**OFFICE OF THE PRINCIPLE CHIEF CONSERVATOR OF FOREST, HOFF,
RAJASTHAN, JAIPUR**

In referenced to para 21/N, CCF resubmitted the proposal after amendment corrections. User Agency submits digital maps of the proposal FP/RJ/Road/6997/2014 as per required by MOEF & CC for their letter no.8B/Raj/06/26/2015/FC/For-3 dated 05.04.2016. After examination of digital maps some query in the submitted digital maps.

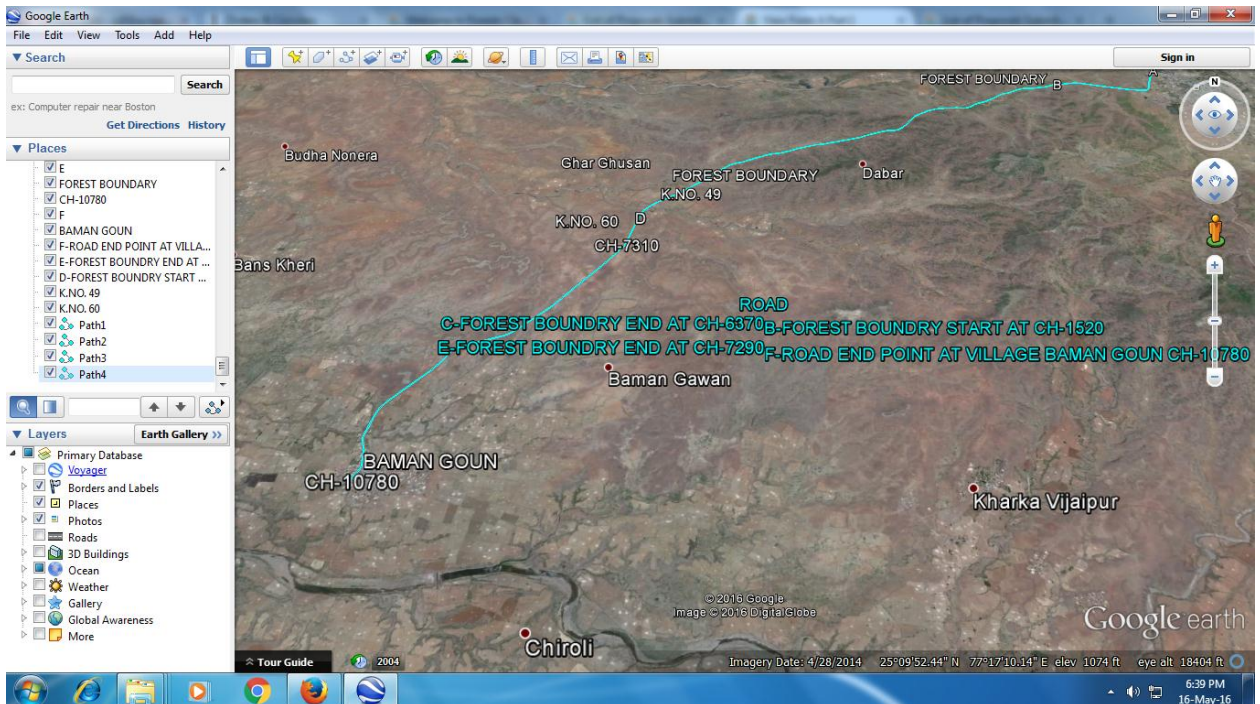
1. Digital Maps are in polyline shape while MOEF & CC required digital maps in polygon shape for DSS analysis.
2. Sheet No 1 expressed that provided digital maps are prepared in path. Total path are 4.
3. Sheet no 2 expressed that provided digital maps are in line shape.
4. Sheet No 3 expressed that provided digital maps have a length of 9724 meter in forest while the length of road in forest is only 4850 meter.
5. Digital maps shows only forest area while the proposal has non forest land therefore non forest land details should be shown in KML file.
